Subject: Transmittal of Revision 1 to Service Bulletin Number V2500-NAC-78-0125

NACELLE - EXHAUST - THRUST REVERSER LOWER CROSS TIE ASSEMBLY - MODIFICATION OF

Internal Reference No.
LL/AC 96VN800

## V2500 Propulsion System — Nacelle

Lower Cross Tie Assembly Modification/Upper Cross Tie Assembly Bushing Inspection and Damage Removal Figure 1 (Sheet 1)

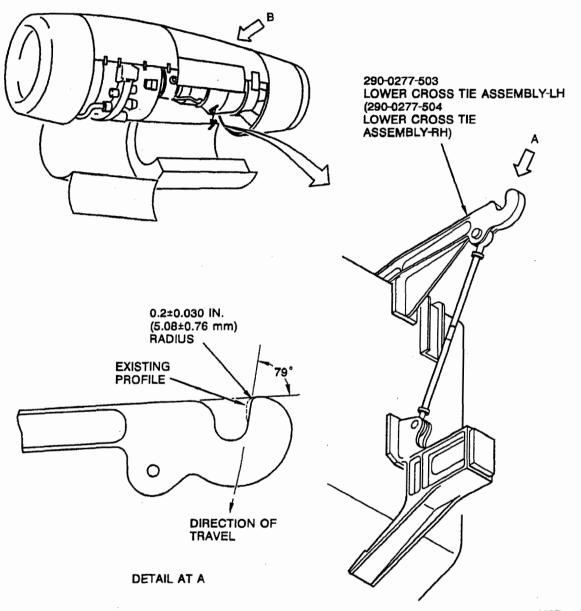
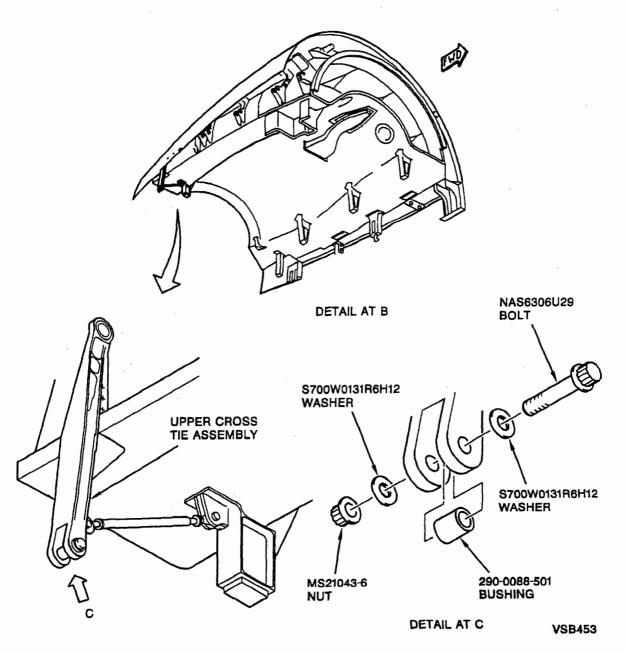
- B. Rework or Modification Instructions
  - (1) Modify the 290-0277-503 (LH) or 290-0277-504 (RH) lower cross tie assembly. Refer to Figure 1.
    - (a) Machine the indicated material from the hook area of the 290-0277-503 (LH) and 290-0277-504 (RH) lower cross tie assemblies.

- (2) Inspect the 290-0088-501 bushing on the 290-0276-503 (LH) or 290-0276-504 (RH) upper cross tie assembly for surface damage. If damage is found, remove the damage as instructed in paragraph B.(3). If no damage is found, go to paragraph 2.C. Post Requisite Instructions. Refer to Figure 2.

- (3) Remove surface damage from the 290-0088-501 bushing. Refer to Figure 1.
    - (a) Remove the MS21043-6 nut, S700W0131R6H12 washer, NAS 6306U29 bolt, and 290-0088-501 bushing from the upper cross tie assembly.

- (b) Remove any surface damage from the 290-0088-501 bushing with CoMat 05-082 aluminum oxide abrasive paper.
- (c) Install the MS21043-6 nut, S700W0131R6H12 washer, NAS 6306U29 bolt, and 290-0088-501 bushing on the upper cross tie assembly.
